Cumulative Impact of Development on the Havant Strategic Road Network Junction Cluster

Campdown (APP/23/00488) and Southleigh (APP/26/00324)

For inclusion in the planning file for: APP/23/00488 (Land East of College Road, Campdown/Purbrook) and APP/26/00324 (Southleigh strategic site) – requested for addition to both case files

Prepared by: [REDACTED], Havant Civic Society, 26 July 2026

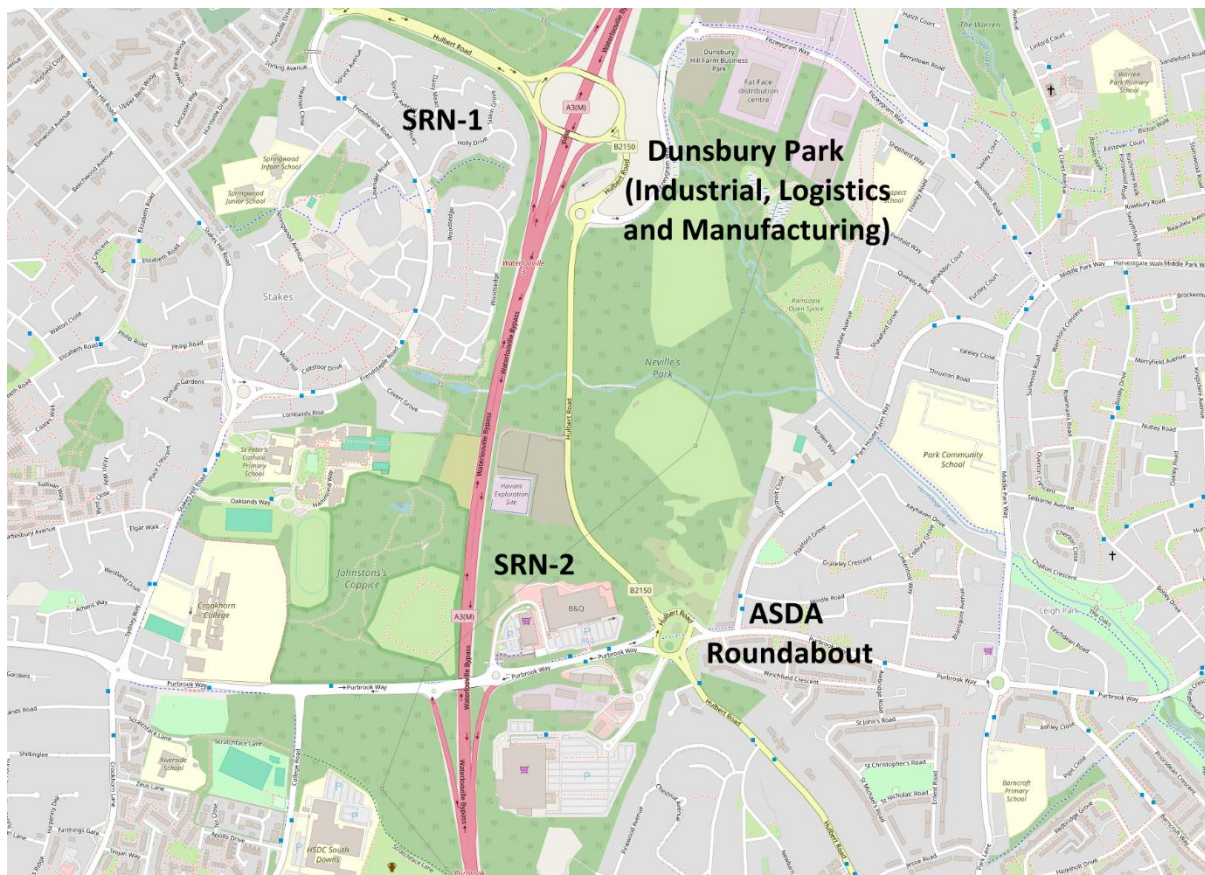
There is widespread public agreement with the Agency's concerns regarding capacity-related queuing at and between junctions on the local road network in the vicinity of A3(M) J4. This junction by its design requires the nearby 'Asda roundabout' on Purbrook Way to provide A3(M) access to the north.

Despite extensive reconstruction and enlargement in 2015, there are now substantial queues forming at this roundabout at peak times. A comprehensive review of the signalling system is urgently needed to manage peak and seasonal 'pulses' of vehicle movements generated by Asda retail store traffic, Amazon DSP³ despatch waves and the newly opened flagship Lidl store⁴ which began trading in March 2026 at the Junction 4 east side 'B&Q' dumbbell roundabout.

There are also capacity-related queuing issues at peak times in the vicinity of the A3(M) J5, notably on the 'Teardrop' interchange between the 'Rusty Cutter' roundabout and the A27.

These issues, together with the limitations of access to the SRN via these junctions gives rise to rat-running on the local road network, a problem magnified since Amazon's DPO1 site began operations at New Lane in 2023.

A strong argument could be made for deferring any decision on planning application APP/23/00488 at Campdown until approval for a pre-requisite signalling upgrade to the Asda roundabout is given. Cumulative traffic generation associated with the recently opened Lidl retail store, the proposed Campdown development and the nearby proposal for Hulbert Road
